Ainley Farm Environmental Impact Study: Addendum

Prepared for Black, Shoemaker, Robinson, Donaldson

Date: 24 July, 2019

Appendix 1. Response Matrix for GRCA Comments dated July 31st, 2018

Figure 1: Ecological Land Classification, Wetland Locations, Wetlands and Woodland Boundaries

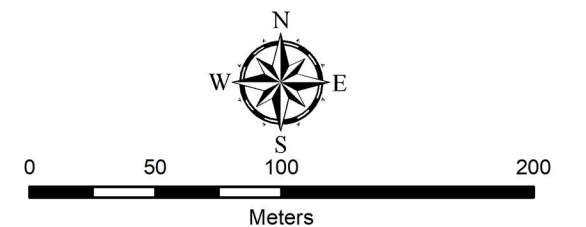
| GRCA Comment | Response |
|---|---|
| 6. As indicated in the 2014 GRCA response to the Terms of Reference, the wetland boundary should be staked in the field then confirmed by GRCA staff. This work should be completed between May and October. The appropriateness of treating portions of the wetland feature as anthropogenic wetland should be confirmed while in the field. | Wetland and woodland boundaries were staked on September 4, 2018 as discussed in Section 2 |

Wetland and woodland boundaries were surveyed in areas in proximity to proposed development by a hand-held GPS on September 4th, 2018 (Garmin GPSMAP 64csx, accurate to 3.6m), with Ryan Hamelin of Grand River Conservation Authority (GRCA). Boundaries determined during the field visit (as well as the other ELC boundaries) are shown on Figure 1.

A small wetland on the northwest boundary, noted in the previous EIS (NSE 2017), which was previously dominated by Red-osier Dogwood (*Cornus stolonifera*), was noted at the time of the field visit to have succeeded to a thicket dominated by Red Raspberry (*Rubus idaeus*), Common Buckthorn (*Rhamnus cathartica*) and Red Current (*Ribes rubrum*): all species not considered wetland plants according to the Ontario Wetland Evaluation System (OWES: MNR 2014, Appendix 10). Since this community is dominated by over 50% upland vegetation it was agreed (in consultation with Ryan Hamelin) that it no longer qualifies as a wetland.

Figure 2: Proposed Development and Constraints

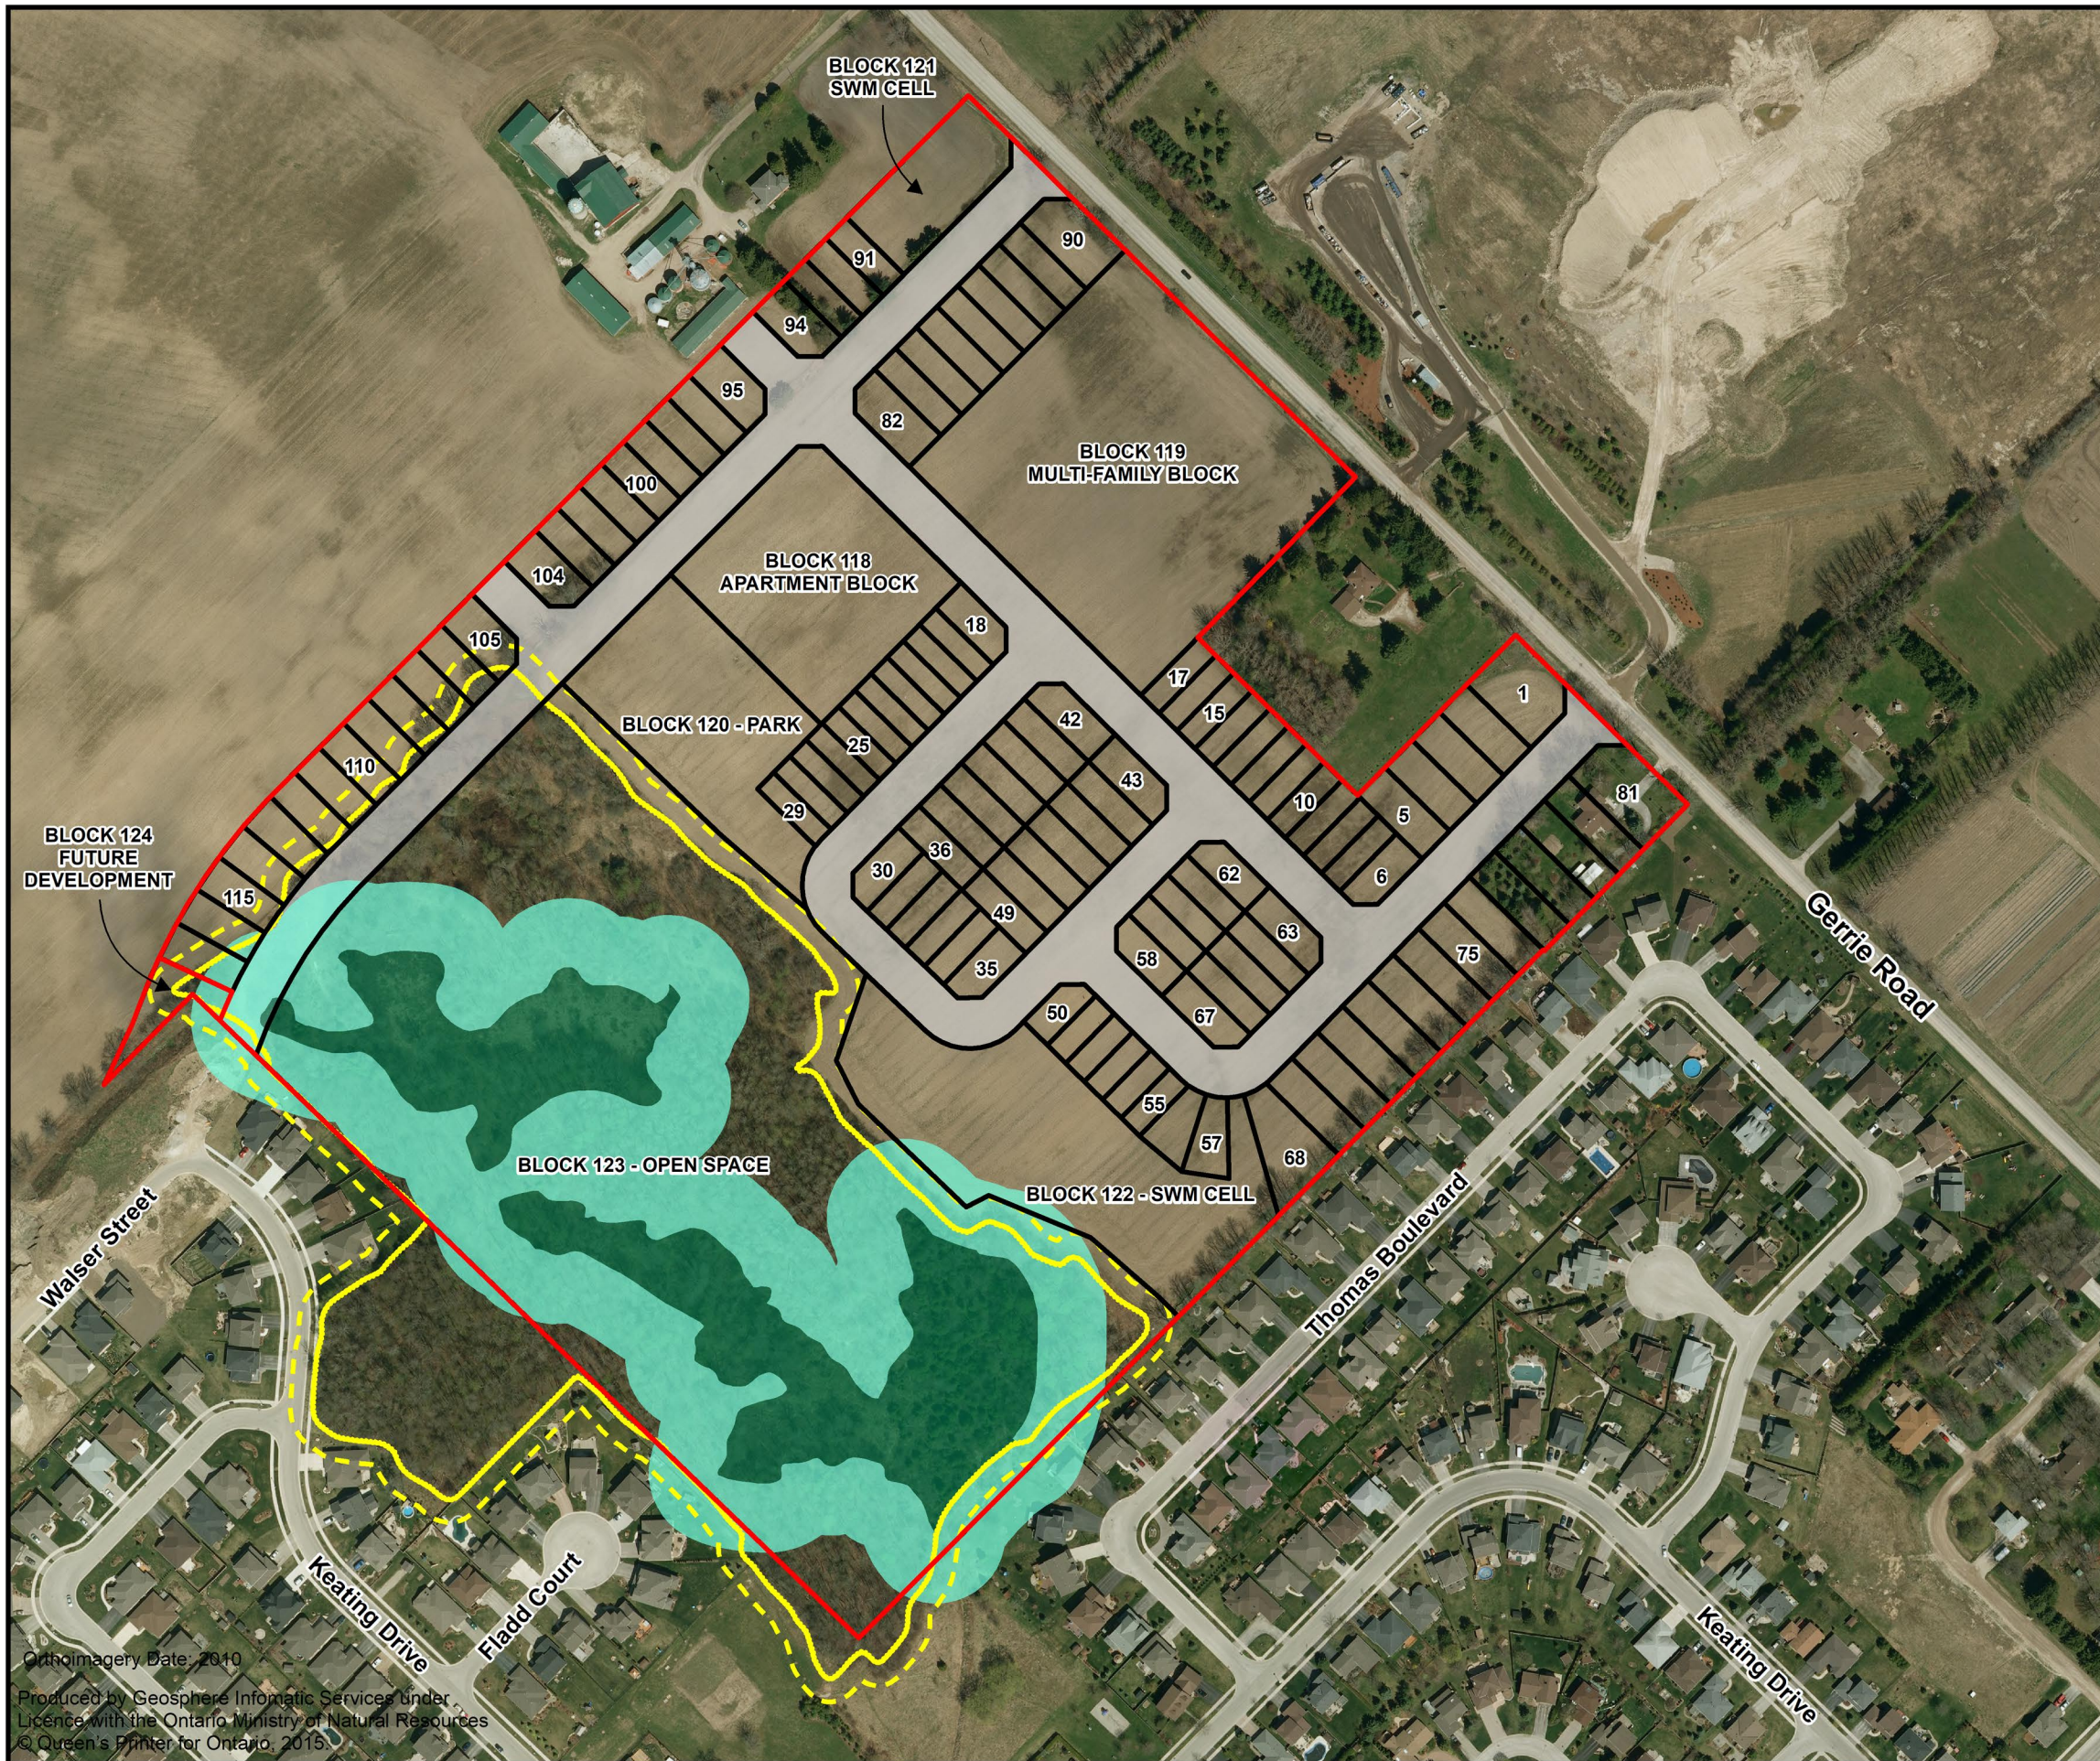
| GRCA Comment | Response |
|---|---|
| 9. The EIS does not provide sufficient rationale for the proposed wetland buffer and buffer encroachments. Please provide additional rationale for the buffer limits and any encroachments. | The site plan has been revised to provide additional setbacks as discussed in Section 6 of the EIS Addendum. Rationale for revised minor encroachments is provided in Section 6. Mitigation for encroachments is described in Section 7 of the EIS Addendum |

The site plan has been revised to provide the following environmental setbacks, as shown in Figure 2:

- 10 m buffer to woodland dripline;
- Setback of between 30 m and 12 m from the southeastern wetland boundary.

Development of the storm cell is proposed within a small portion of the Area of Interference for the southeastern wetland. The area proposed for development has been used in the past for intensive agriculture, and is regularly ploughed each year. The proposed storm cell development is not expected to cause additional impacts, with mitigation in the form of restoration. Proposed restoration for this area is addressed in Section 7.
